ALTERNATIVE METHODS OR CONSTRUCTION MATERIALS REQUEST

PRAMR20221054

PROJECT NAME: Valley Avenue Contractors Yard

SHEET TITLE: PRELIMINARY SITE PLAN
AMR REVIEW
DRIVEWAY LOCATION

Preliminary Site Plan - Driveway Exhibit

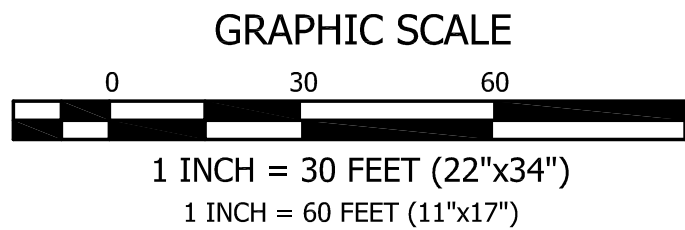
City of Puyallup Standard Detail 01.02.16, Standard Commercial Driveway Approach, notes 5 & 6 state that spacing for a new commercial driveway approach shall be a minimum of 300' measured between the closest edges of each driveway. Also applies to driveways across the street. A new commercial driveway approach is being proposed, however there is no location along the project site frontage that would comply with the standard spacing requirement.

The proposed location for the new driveway is in the middle of the two closest driveway approaches, both located across Valley Avenue. The proposed location is close to the midpoint of the project sites frontage. The proposed driveway approach will comply with all other city standard requirements and has been sized appropriately (40 feet wide) for the largest possible vehicles (WB-67 Truck and Trailer) that would be accessing the project site.

Strict application of the requirement for minimum spacing between existing driveways on both sides of the street for a new commercial driveway approach would result in no location on the project site being compliant with the spacing requirement. Valley Avenue is a major/principal arterial type street, requiring 300 feet of spacing between new driveways. Multiple commercial driveways already exist across Valley Avenue and to the SE of the project site. The available frontage of the project site is only 195 feet and any proposed location for an adequately sized driveway would be within 300 (and within 150) feet of an existing driveway.

The proposed driveway would be designed and constructed to comply with all requirements of the City of Puyallup Municipal Code. The driveway will be paved and sized adequately for all types of vehicles anticipated to access the site. Proper site lines will be maintained at the driveway approach. The two (2) existing residential driveways on the project site will be closed to remove existing points of conflict with the new driveway.

STAFF RECOMMENDATIONS	APPROVED	DENIED	DATE
Development Engineering			07/12/2022
Conditions: Request to vary driveway spacing approved based on existing frontage length. FINAL LOCATION OF THE DRIVEWAY ACCESS SHALL BE DETERMINED BY TRAFFIC ENGINEERING.			
Planning Department	NOT APPLICABLE		
Conditions:			
Traffic Engineering	BR		08/19/2022
Conditions: The proposed non-standard driveway placement (substandard spacing and driveway alignment) is acceptable for the proposed land use only (contractor yard/outdoor storage). This AMR approval does not vest driveway design or placement for future development beyond what is currently being proposed (extremely low site generated volume assumed). Negative offset driveway alignments can cause inbound left turn conflicts with adjacent driveways (especially for large vehicles).			
Public Works - Streets	Per Email dated 7/14/22		
Conditions: Mark, I will approve it. The offset of this driveway to the approach across the street is pretty much the same as the next commercial driveway just to the east. I do not know the expected daily trips in and out of this approach, they say it will be a construction yard.. Having said that I typically would refer to Bryan.
